Millstone Nuclear Power Station, Unit No. 2  
NUREG-0737 Item II.B.3 Post Accident Sampling System

MILLSTONE NUCLEAR POWER STATION, UNIT NO. 2  
POST ACCIDENT SAMPLING SYSTEM  
NUREG-0737 ITEM II.B.3

MILLSTONE NUCLEAR POWER STATION, UNIT NO. 2  
POST ACCIDENT SAMPLING SYSTEM  
NUREG-0737 ITEM II.B.3

## MP2 PASS SYSTEM DESCRIPTION

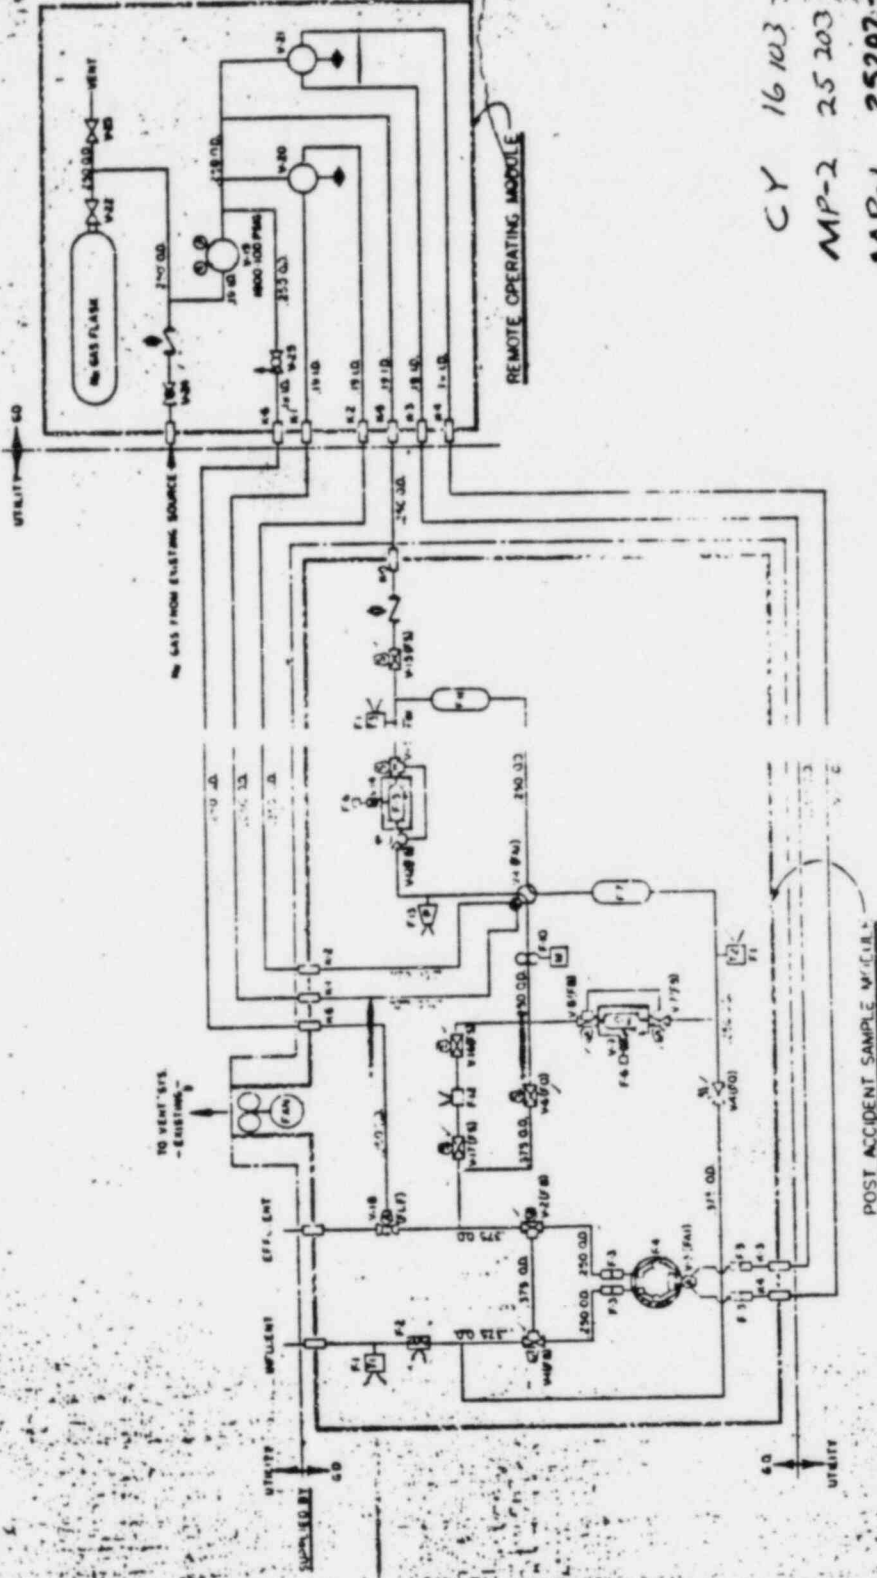
Clarification: System schematics and discussions should clearly demonstrate that post accident sampling, including recirculation, from each sample source is possible without use of an isolated auxiliary system. It should be verified that valves which are not accessible after an accident are environmentally qualified for the conditions in which they must operate.

Response: The reactor coolant PASS is a remotely operated system designed to obtain samples which have been diverted from the normal sampling system. Sample flow and flushing are controlled with air and solenoid operated valves. The sample module is attached to the existing sample system in the primary sample room through the use of three manually operated three way valves.

The driving head which forces the sample to the PASS is the reactor coolant system pressure. The driving heads for LPSI/HPSI/Containment Spray samples are the pumps associated with the system on line at the time. Maximum design temperature for the PASS sample module is 165°F. Cooling for the sample is provided by the sample system cooler X-64, which is cooled by Reactor Building Closed Cooling Water system. All PASS isolation valves that are not accessible after an accident are environmentally qualified for conditions under which they must operate.
